**Addendum Number Two**  
To The Drawings and Specifications for  
**Red Brick (East and West) Restrooms at Lake Afton**  
**Bid # 24-0071, Sedgwick County, Kansas**

**ADDENDUM TWO**

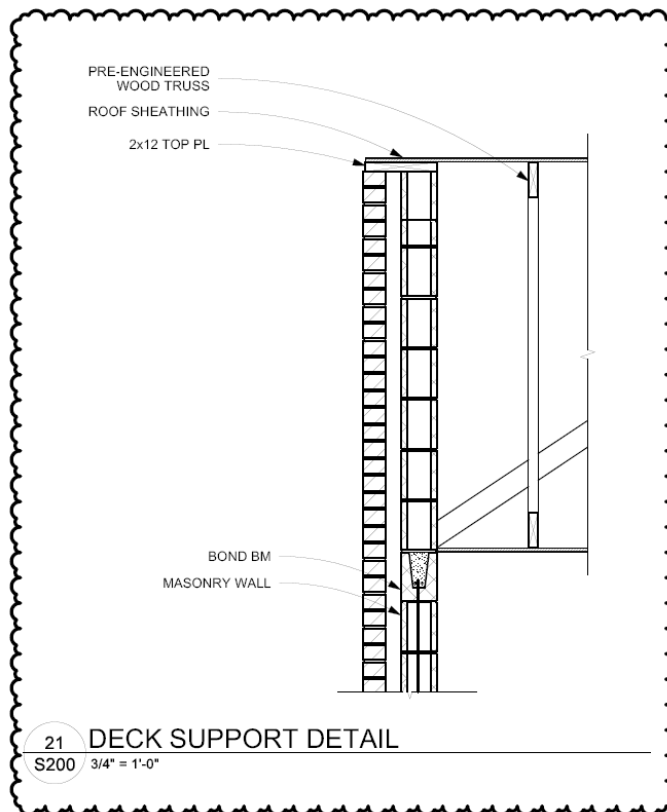
- 1.1 The Bid Date and Time shall remain unchanged.
- 1.2 Structural Sheet S200, Detail 21 shall be replaced by the detail below showing full height brick that matches the architectural drawings.
